ST. LUCIE UNIT 1

MARKED-UP TECHNICAL SPECIFICATION PAGES

AXIAL SHAPE INDEX LIMITS EXPANSION

FIGURE 2.2-2
Local Power Density-High Trip Setpoint Part 2(QR₂ Versus Y₁)

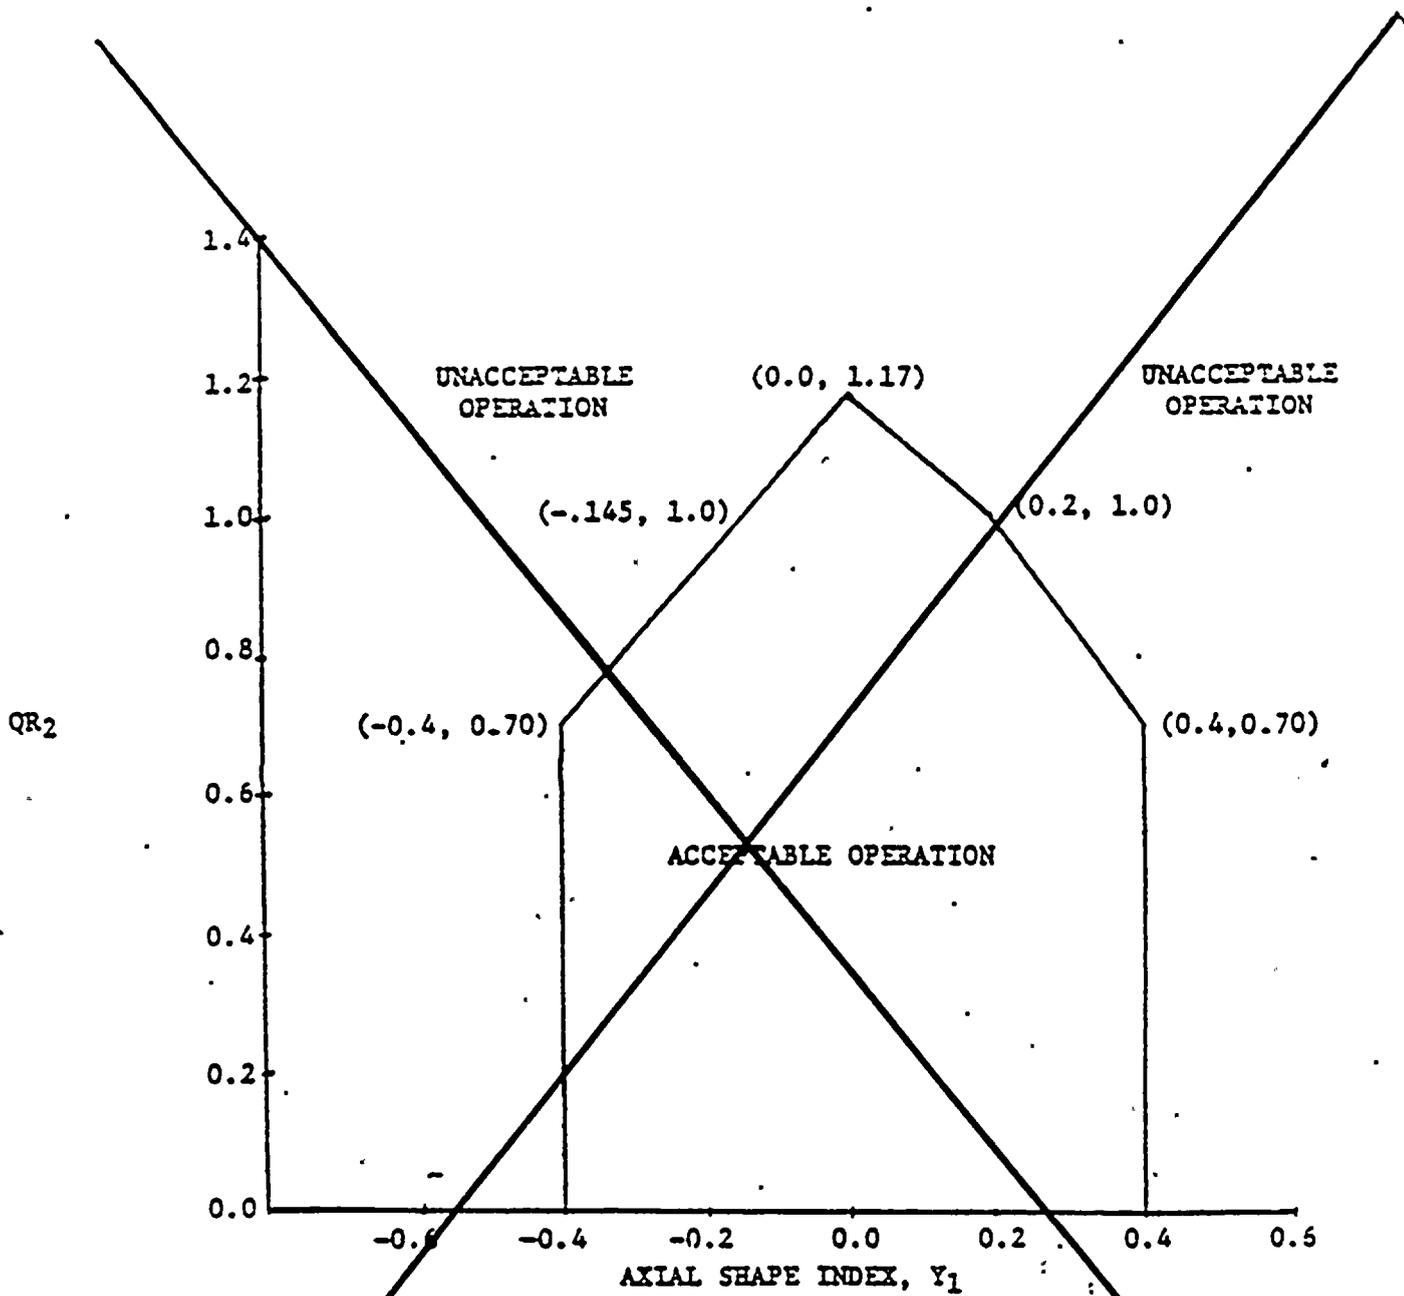
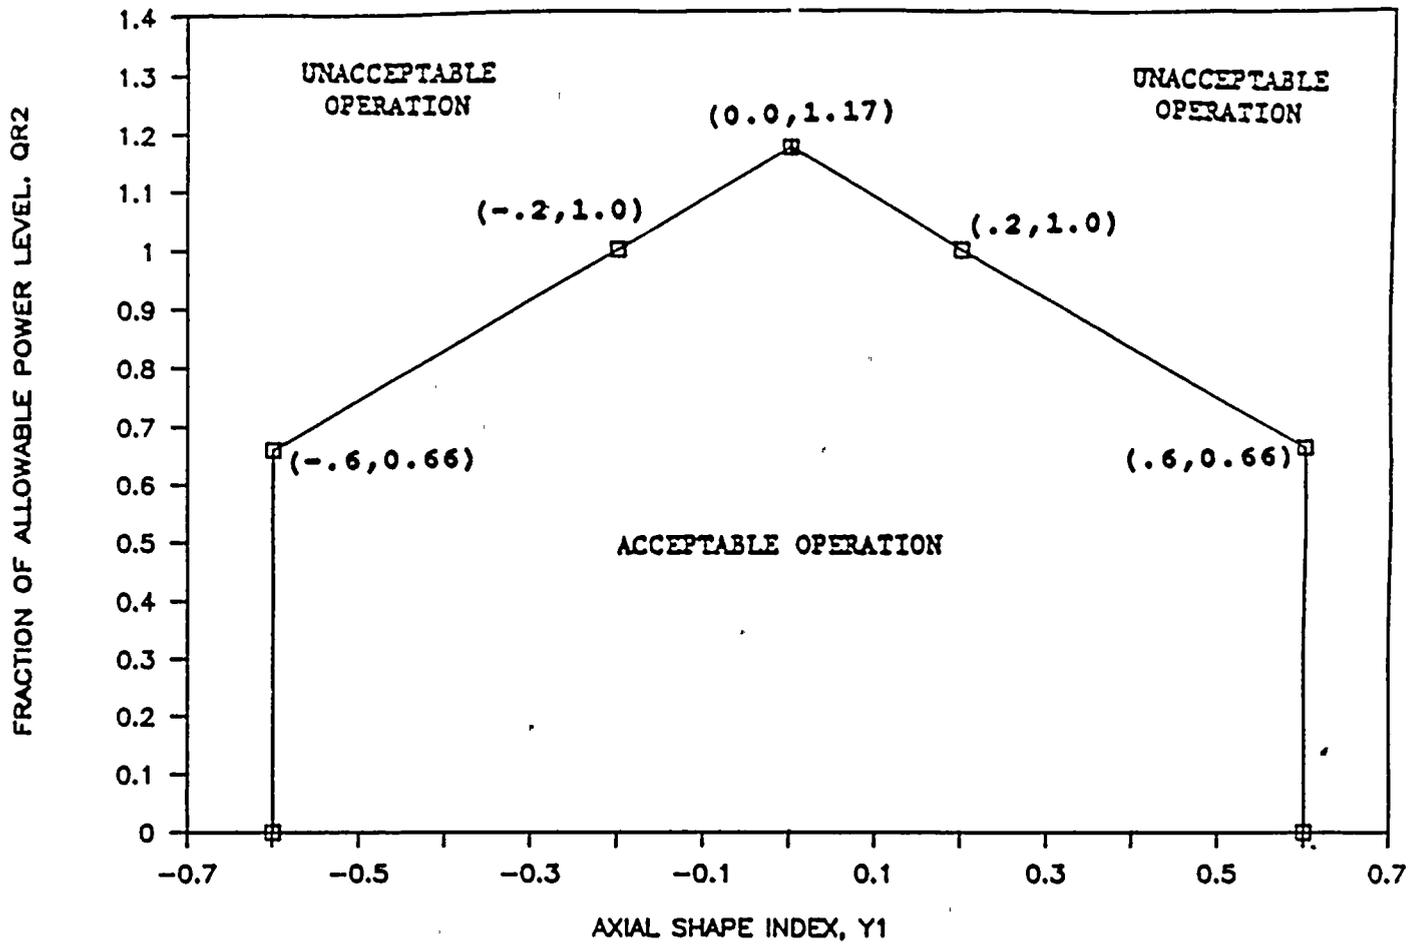
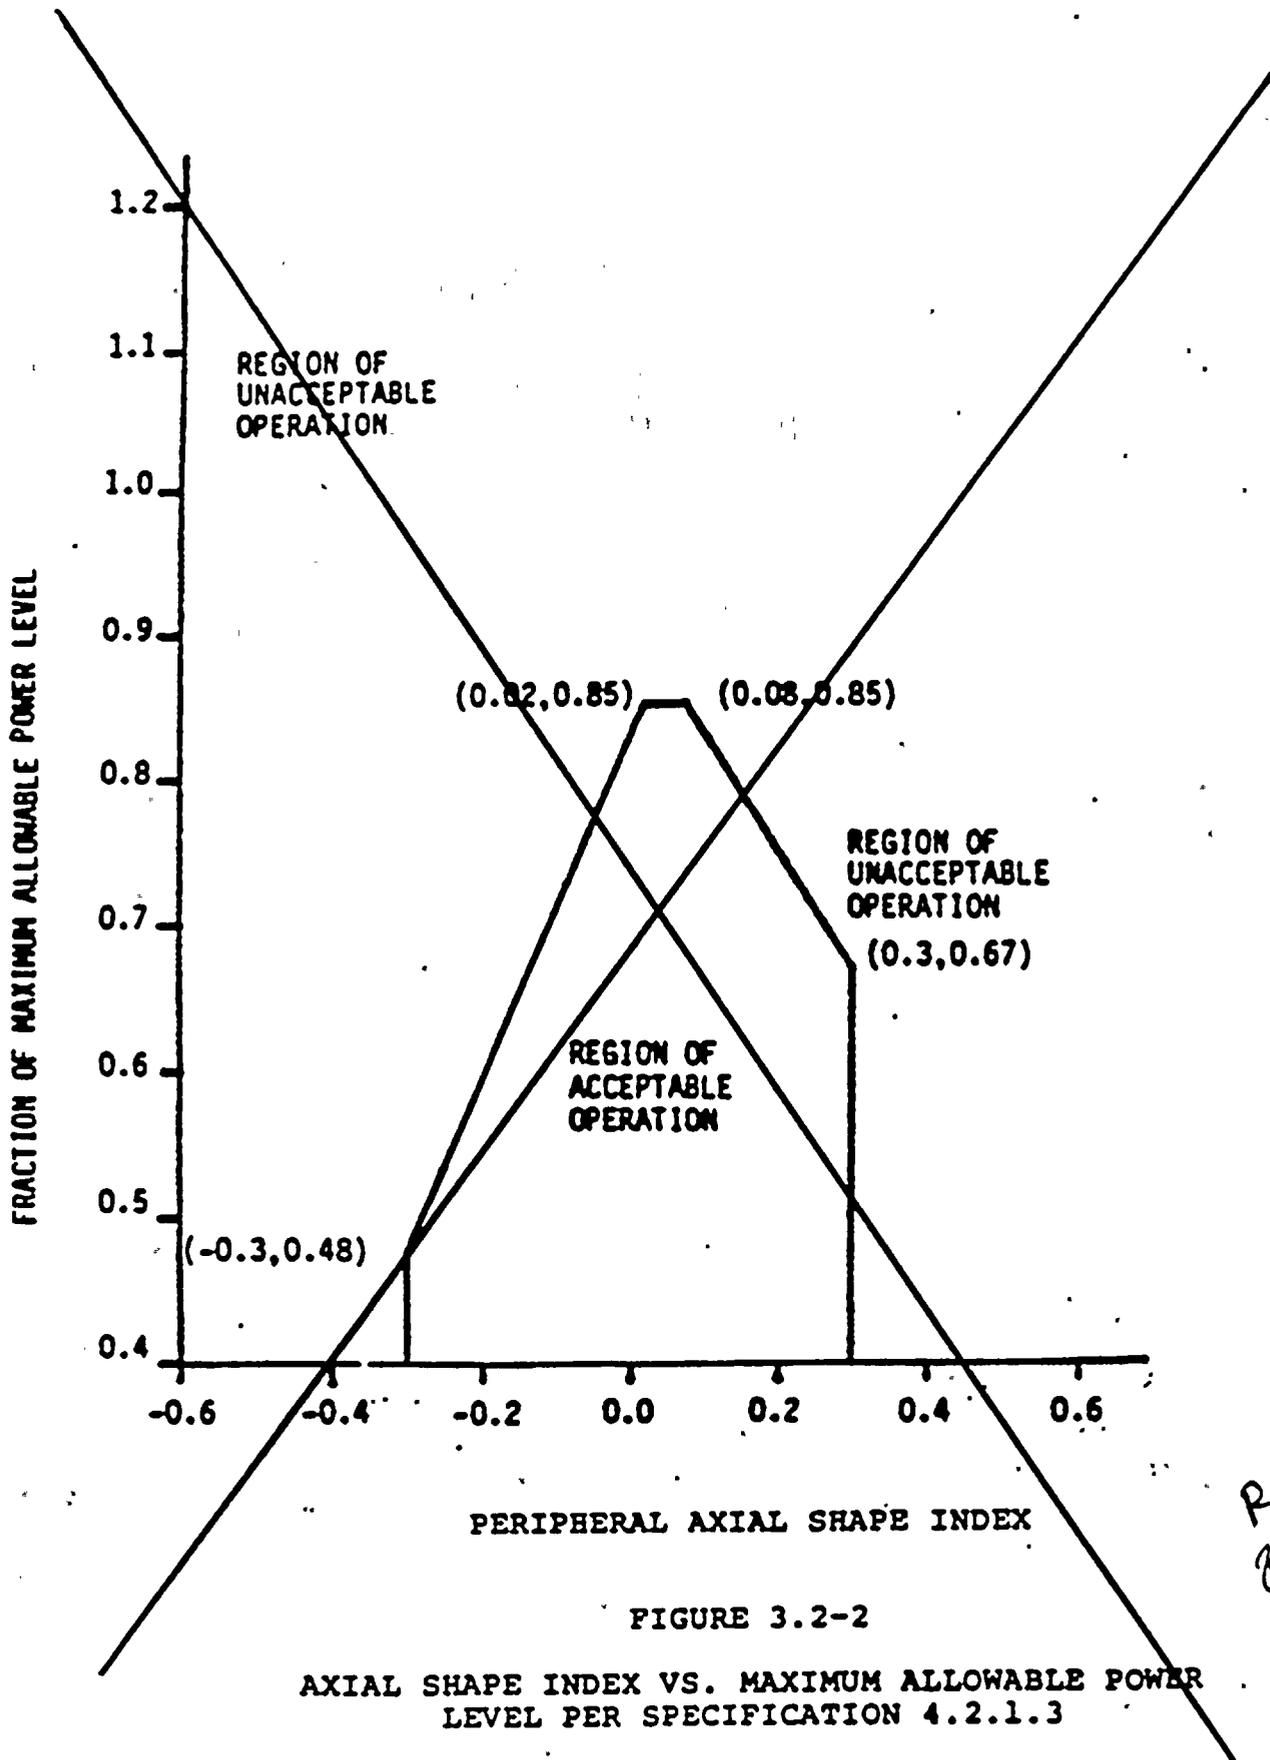
*Replace with
Insert Attached*

*Replace with
Insert attach*

It is proposed to expand the LPD LSSS ASI limits for power levels below 66% from ± 0.4 to ± 0.6 and for 100% power level from -0.145 to -0.2 . It is also proposed to expand the ASI limits of the LPD LCO for power levels below 45% (but above 40%) and the ASI limits of the DNB LCO for powers below 65% (but above 40%) from ± 0.3 to ± 0.5 . In addition changes were made to ASI limits of the LPD LCO at 85% power level from 0.02 to -0.08 .

FIGURE 3.2-4
 AXIAL SHAPE INDEX Operating Limits With 4 Reactor Coolant Pumps Operating

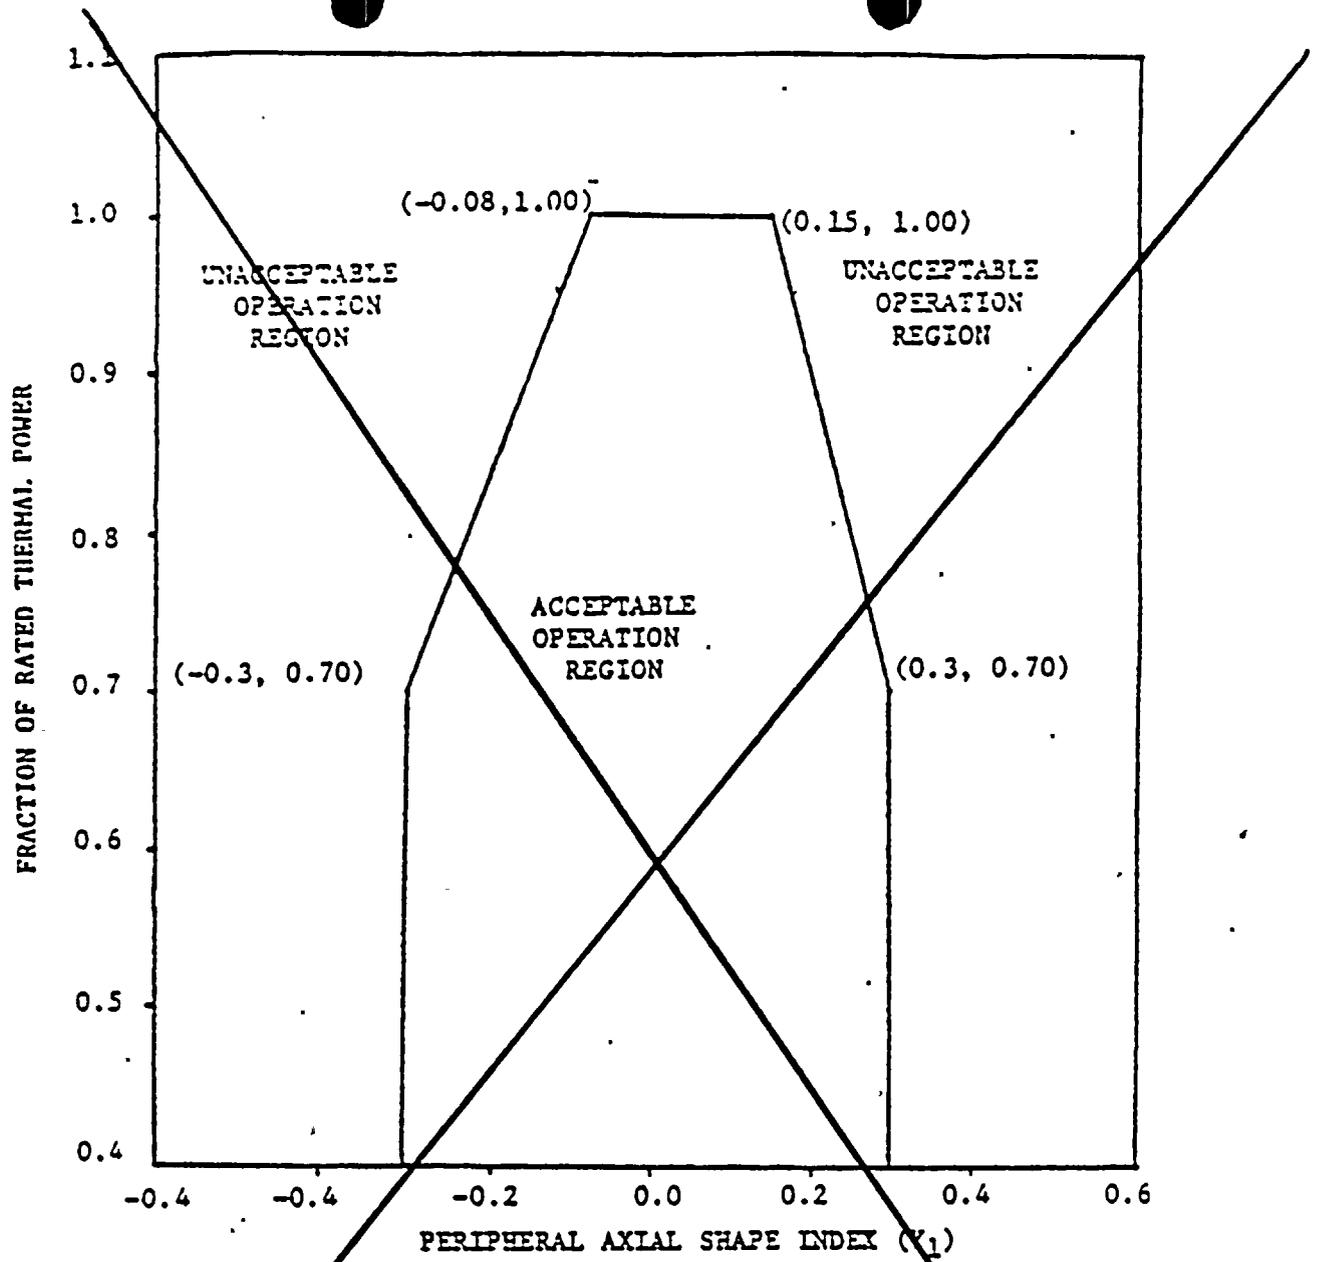
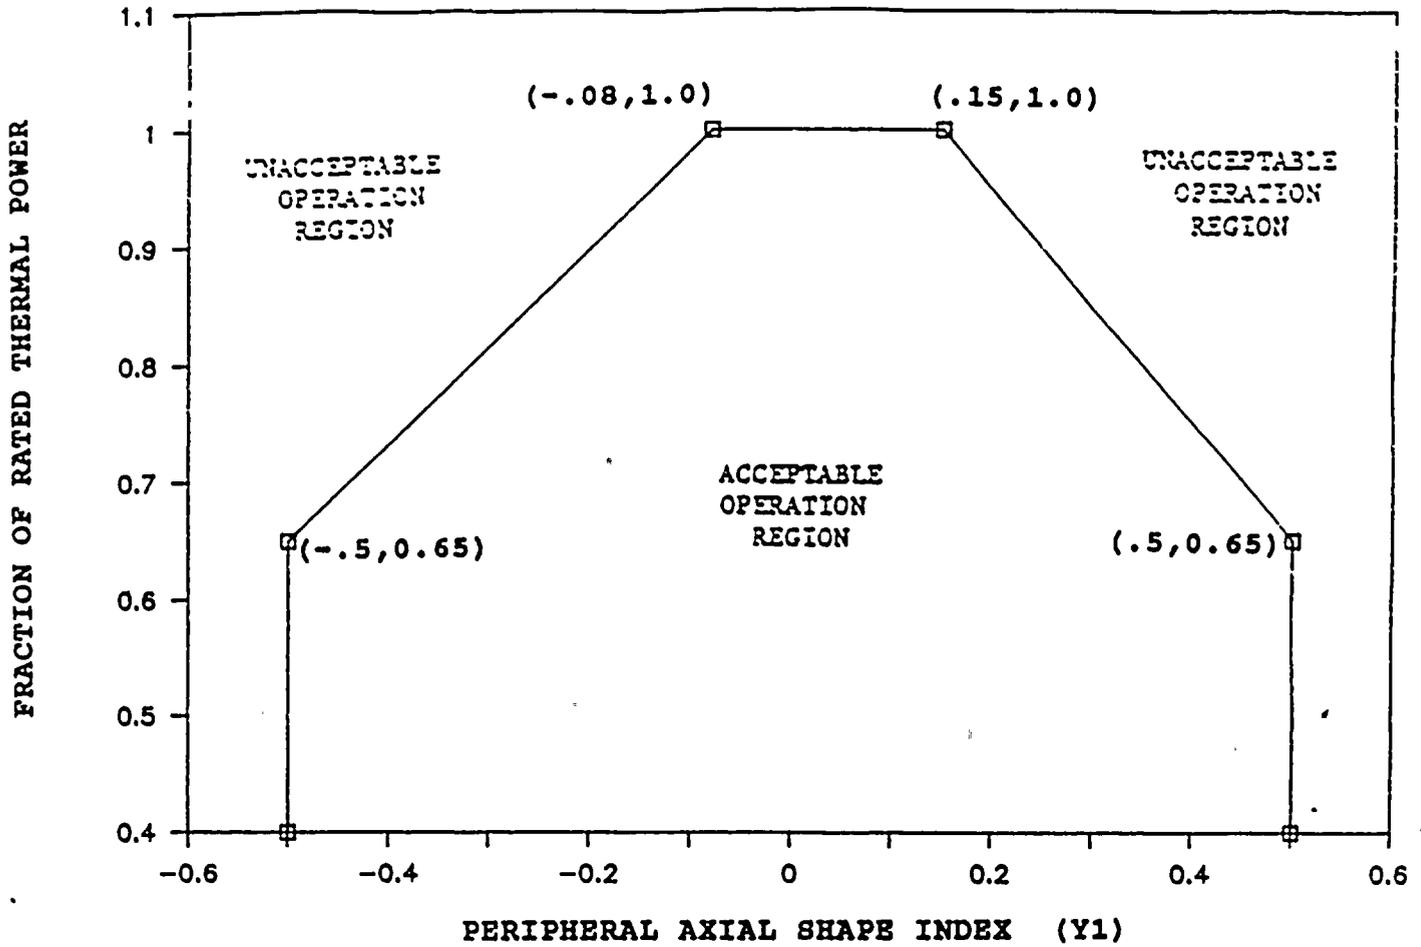
*Replace with
 Insert Attached*

To achieve greater operational flexibility at lower power, expansion of the Axial Shape Index (ASI) limits for the Departure from Nucleate Boiling (DNB) and Local Power Density (LPD) Limiting Condition for Operation (LCOs) and the LPD related Limiting Safety System Setpoints (LSSS) is proposed. The proposed change modifies the Local Power Density LSSS (Technical Specification Figure 2.2-2), the LPD LCO (Technical Specification Figure 3.2-2) maximum allowed power level versus peripheral Axial Shape Index (ASI) for ex-core detector monitoring system, and DNB LCO fraction of the rated thermal power versus peripheral ASI for four reactor coolant pumps operating (Technical Specification Figure 3.2-4).

FIGURE A

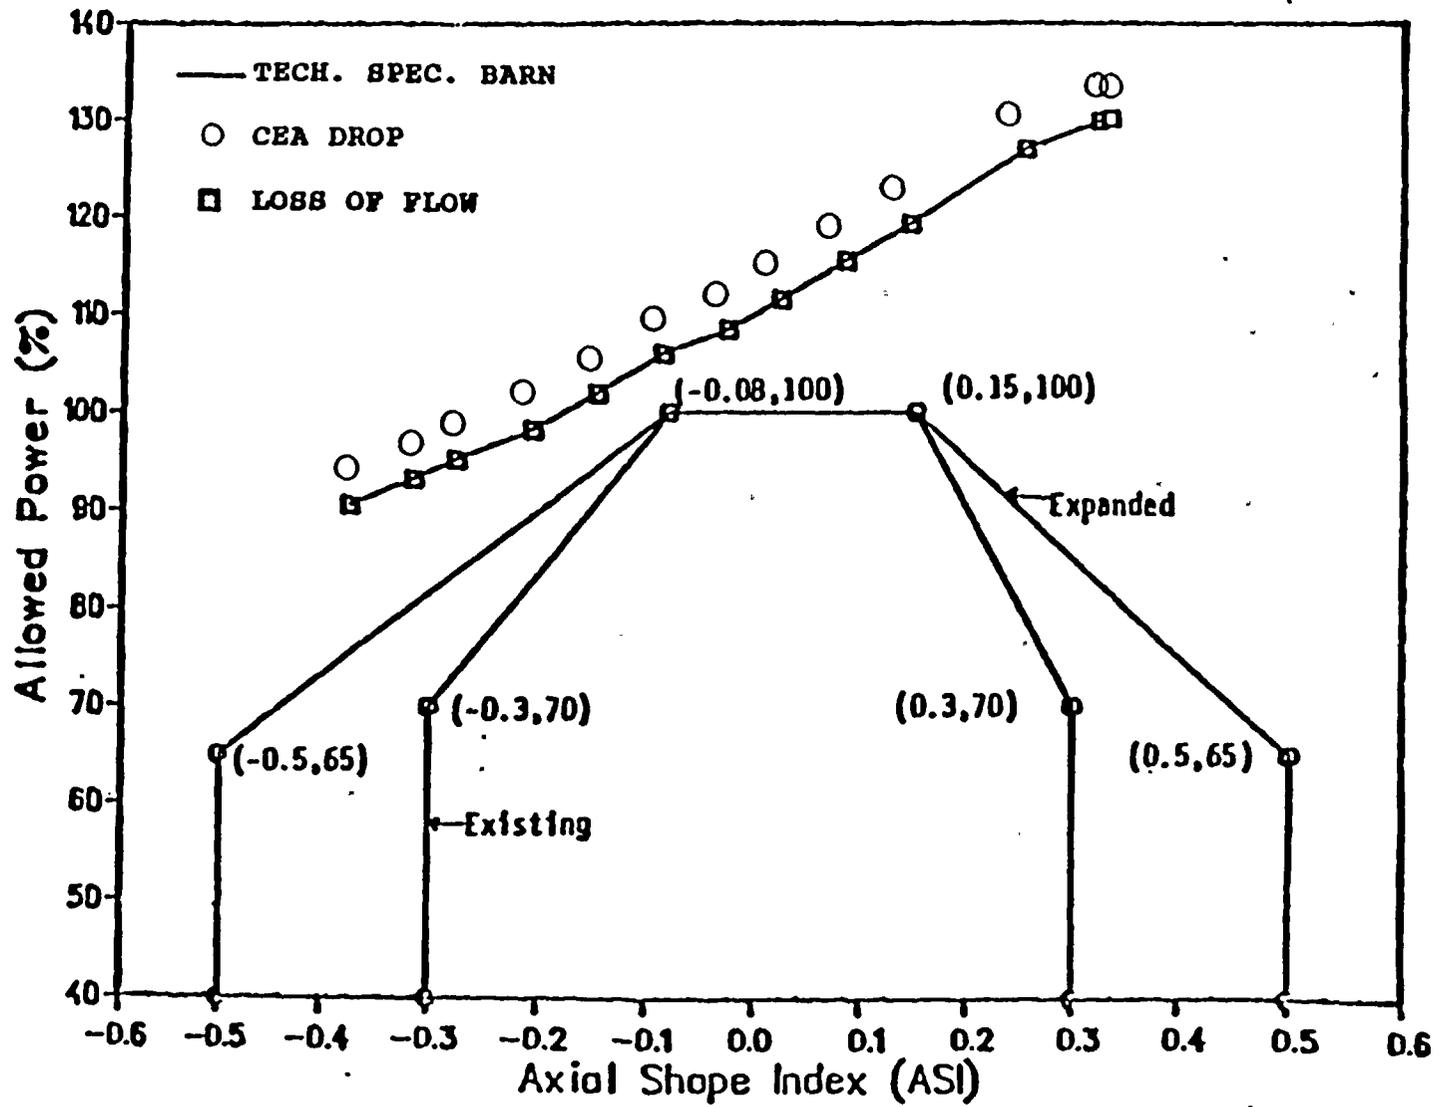
Excess Load and CEA Withdrawal: St. Lucie Unit 1 FSAR shows that the case initiated from hot zero power for CEA Withdrawal and Excess Load are bounded by their respective full power cases. Figure A shows that with the expanded ASI tent, for the Loss of Flow and CEA drop events, the margin in DNBR increases as power is decreased for ASIs less than -0.08. The trend will be the same for DNBRs calculated for CEA withdrawal and Excess Load transients, and the 100% power cases would remain limiting. Also, the variable high power trip would limit power excursions initiated from partial power, so that the maximum core power, and therefore the minimum DNBR, would be achieved in the 100% power cases.
